Water Management Plan Update Process Participant comments received between May 22 and Aug. 15, 2025

Re: Initial Comments on 2025 LCRA Water Management Plan Update

Re: Comments and Questions Associated with LCRA's Update of its 2020 Water Management Plan; Comments from Participant Meeting on June 25, 2025

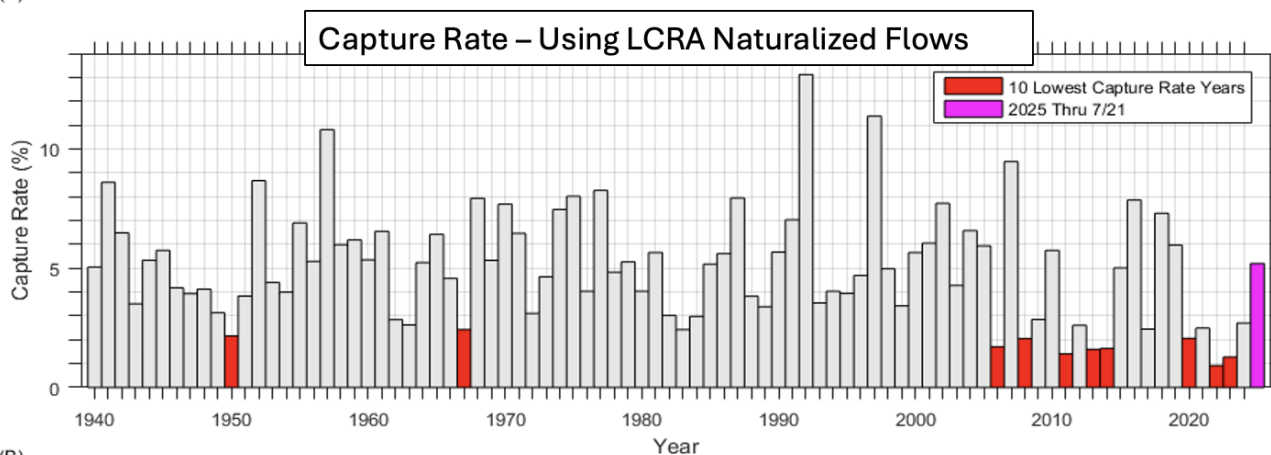
- **Need to Prepare for More Severe Droughts:** While the 2008–2015 drought currently serves as the Drought of Record, historical data shows that rainfall during the 1950s drought was significantly lower. That lower historical rainfall also resulted in higher inflows in the 1950s than is currently produced by the watershed under similar rainfall conditions. This phenomenon is vividly illustrated in the graphic below.

With today's diminished watershed productivity, according to CTWC research, a repeat of 1950s rainfall conditions coupled with today's watershed productivity would likely result in a critical water supply shortage. Raising the minimum storage threshold (from 600,000 acre-feet to 750,000 acre-feet) is a key step toward protecting against this valid and increasingly threatening concern.

CTWC recommends that LCRA raise the **minimum combined storage threshold to at least 750,000 acre-feet**. This adjustment is essential to reflect population growth, increased business demand, reduced watershed productivity, and low rainfall of the 1950's drought. It will reduce risk to firm water customers and provide a more reasonable protective buffer against droughts that may exceed the 2008–2015 drought of record, thereby improving the long-term sustainability of our region's water supply.

Figure 1a: Depletion of WAM-Modeled Combined Storage (2020 WMP & 2025 WMP) compared to actual observed storage from 2007-2017

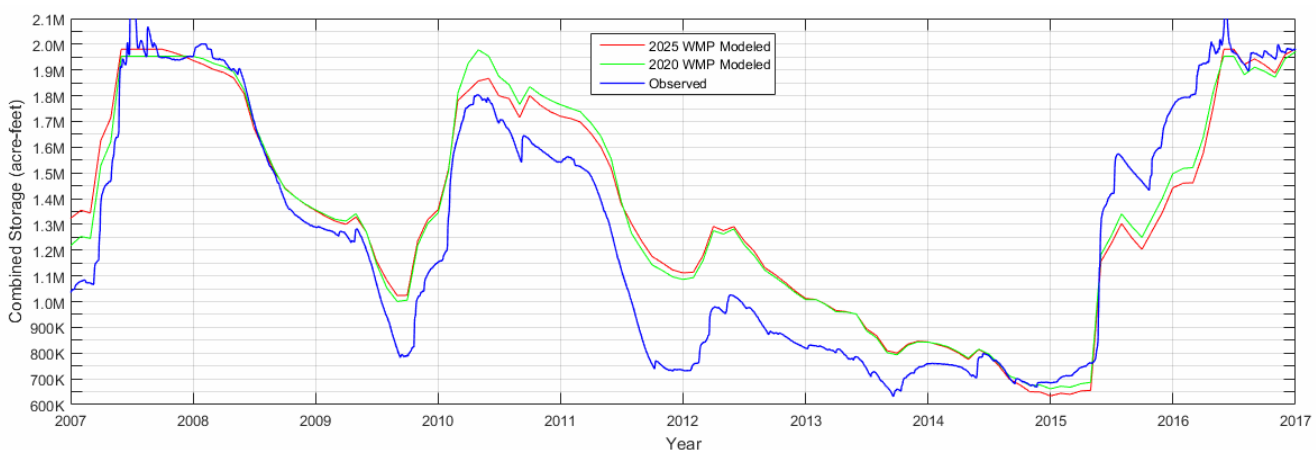
- **Rapid Drawdowns in Modeling:** Our analysis of the WAM outputs based on LCRA's proposed parameters suggests that combined storage can again drop to critically low levels within just 3–4 years. This is particularly alarming when storage dips below 1 million acre-feet, as a repeat of low inflows—such as those experienced in 2022–2023—could leave the system highly vulnerable. According to CTWC WAM runs, the pattern of rapid depletion closely mirrors the risk experienced during the most recent drought cycle (Figure 1a). In fact, modeled combined storage would be lower at the end of 2023 than observed during the current and ongoing drought period (Figure 1b)

- **Inadequate Protection Despite Higher Firm Demand:** Although the updated model incorporates increased firm water demands projected through 2032, it does not appear to adequately adjust for the added risk associated with rapidly depleting storage. CTWC views this as an unacceptably risky strategy, particularly under the new normal of sustained low inflows, increased variabilities, and extended periods of drought.

- Increase the release triggers and adopt more conservative thresholds for interruptible (non-firm) customers—especially during early drought recovery phases.
- Implement early and sustained curtailments of large releases to extend the lifespan of storage during dry periods and improve drought resilience.

Figure 2: 1950s Drought becomes controlling with naturalized flow adjustment based on capture rate – Estimated Adjusted Firm Yield = 234,000 acre-ft/year

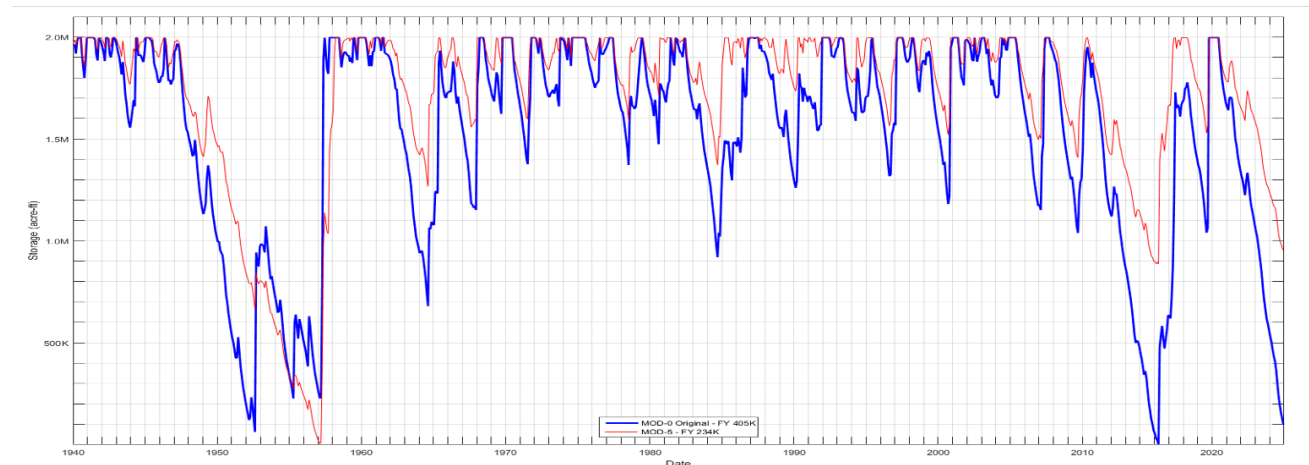
- Adopt a more conservative safe yield approach that reflects today’s reduced inflows, declining watershed productivity, and the possibility of droughts more severe than the 2008–2015 drought of record.
- CTWC research indicates that firm yield could be as low as 234,000 acre-feet if the exceptionally low rainfall of the 1950s drought were to recur under current watershed conditions. This estimate is based on adjusted naturalized flows that incorporate historical rainfall from the 1950s and apply modern assessments of watershed productivity to reflect present-day realities (Figure 2).
